Name Of Dam: STAUNTON DAM  
Location: AUGUSTA COUNTY, VIRGINIA  
Inventory Number: VA. NO. 01518

# PHASE I INSPECTION REPORT NATIONAL DAM SAFETY PROGRAM

**PREPARED FOR**  
**NORFOLK DISTRICT CORPS OF ENGINEERS**  
**803 FRONT STREET**  
**NORFOLK, VIRGINIA 23510**

**BY**  
**SCHNABEL ENGINEERING ASSOCIATES, P.C./**  
**J. K. TIMMONS AND ASSOCIATES, INC.**

**STAUNTON DAM**  
**BASIC SECTION Ogee SPILLWAY**  
 NO SCALE

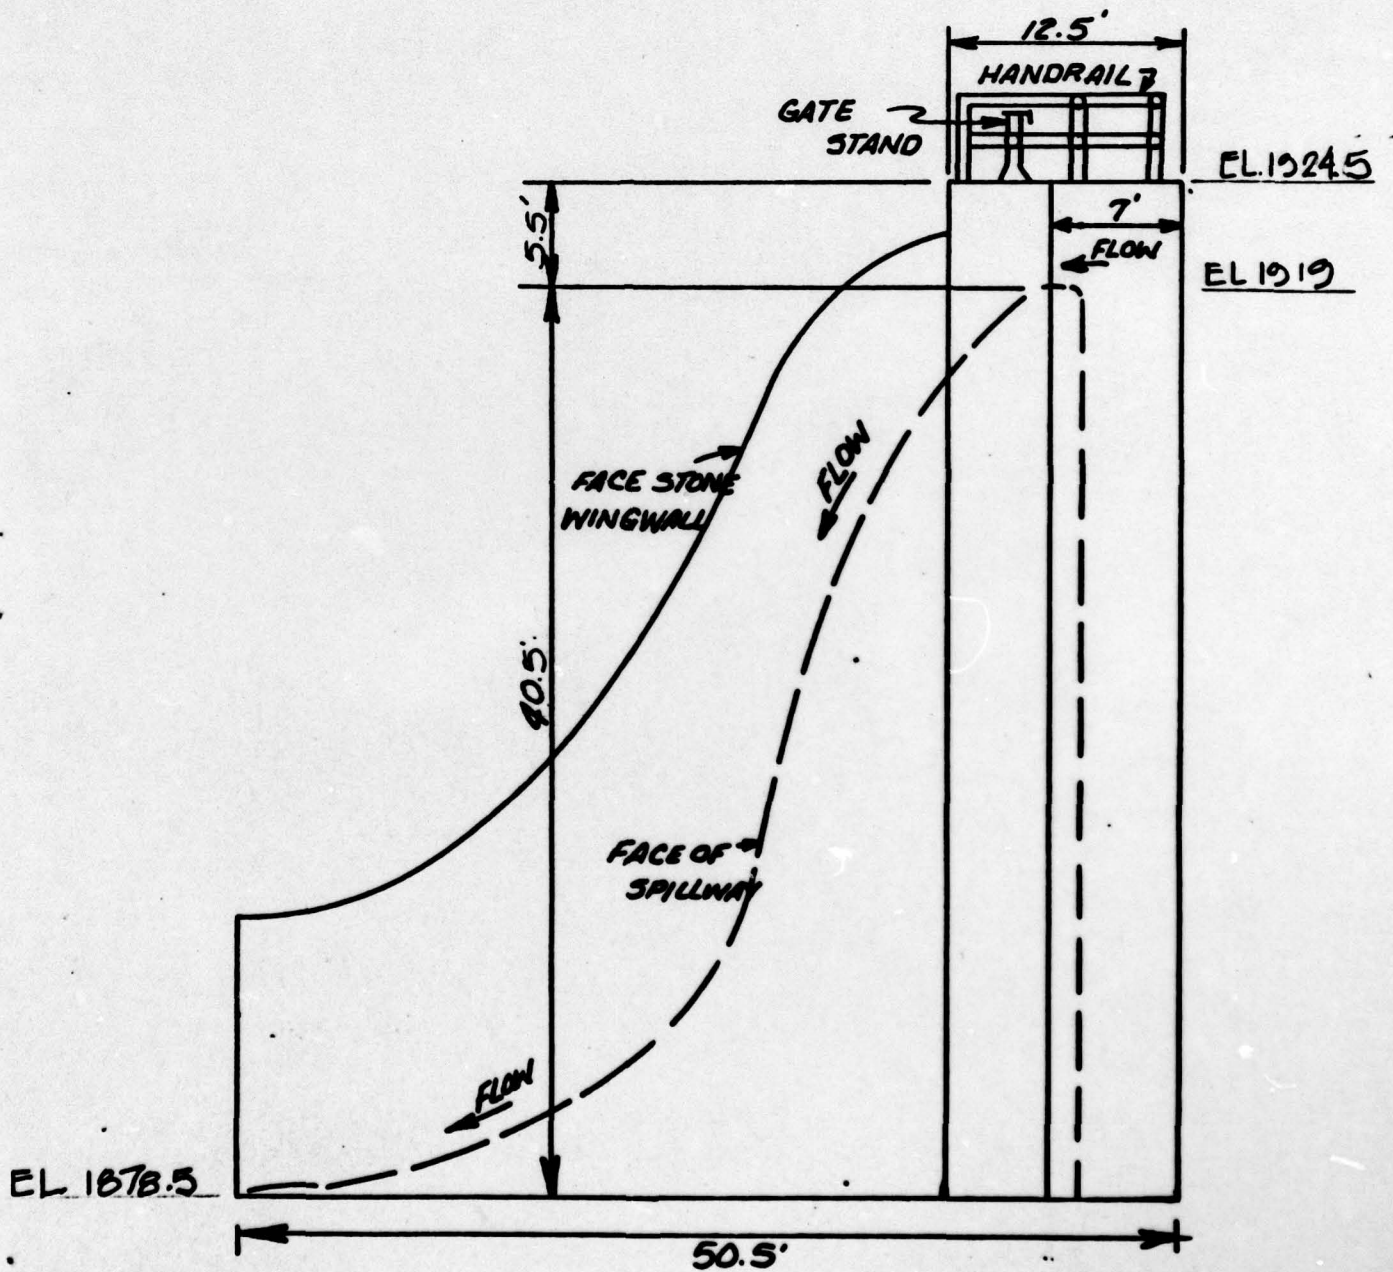
1.2.1 Dam and Appurtenances: Staunton Dam is a concrete, gravity structure approximately 266 ft. long and 46 ft high. The top of the dam is 7 ft wide and is at El 1924.5 M.S.L. A typical elevation and cross section are included on Sheets 2 and 3 of Appendix I. The spillway is Ogee shaped and ungated. As the pool rises, water automatically flows over the spillway. There is a valved 36 inch

# GRAVITY DAM DESIGN STABILITY ANALYSIS

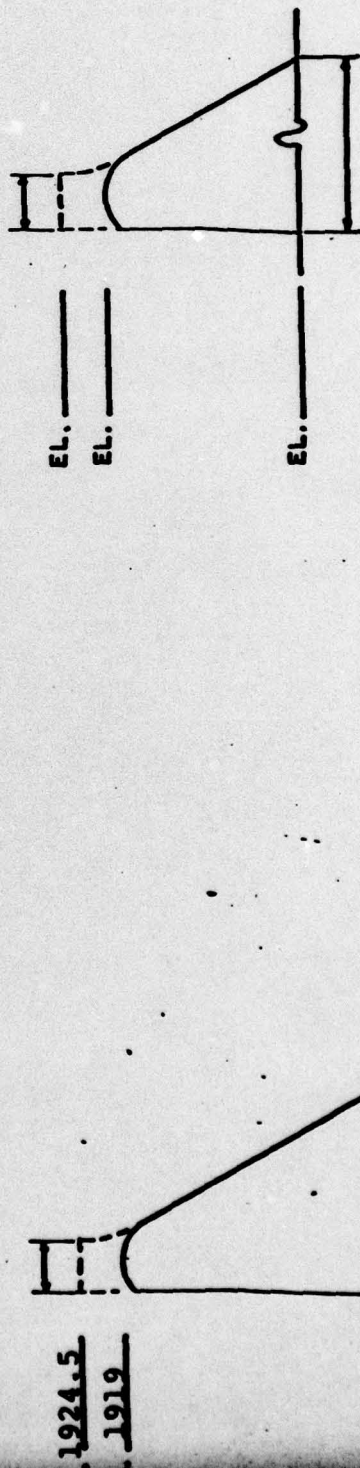
6.2.2 Stability Analysis: An accurate stability analysis could not be made since neither contract drawings nor construction records are available to indicate the foundation embedment. However, an evaluation was made in accordance with Section 4.4 of Reference 1, Appendix V. Assuming the structure resting upon a horizontal bedrock surface, the stability was evaluated with respect to sliding resistance and overturning assuming water at the dam crest, and 14.4 ft over the crest which corresponds to the PMF. Calculations are included in Appendix IV. Factors of safety of 1.35 and 1.32 were obtained for the sliding condition for the two pool level conditions. These factors of safety are substantially less than the factor of safety of 3 required by Reference 1, Appendix V. The stability of the structure with respect to overturning for the two reservoir conditions was also determined. At normal pool, the resultant of all forces

passes within the middle third of the base. Under surcharged conditions caused by the PMF, the resultant of all forces will cause overturning. Without direct evidence that the dam is keyed into the bedrock, and assuming only a surface of bedrock foundation, the dam would be subject to overturning failure under the PMF loading without regard to end restraint.

NOTE: ANALYSIS DOES NOT CONSIDER ABUTMENT END RESTRAINT.

7.3 Investigation by Owner: This investigation should include sufficient subsurface exploration to define the depth of embedment of the structure. The stability of the dam should then be assessed with respect to sliding and overturning utilizing the estimated foundation geometry and estimated strength of the foundation rock and friction resistance of the concrete-rock interface using the methods defined in Reference I, Appendix V.
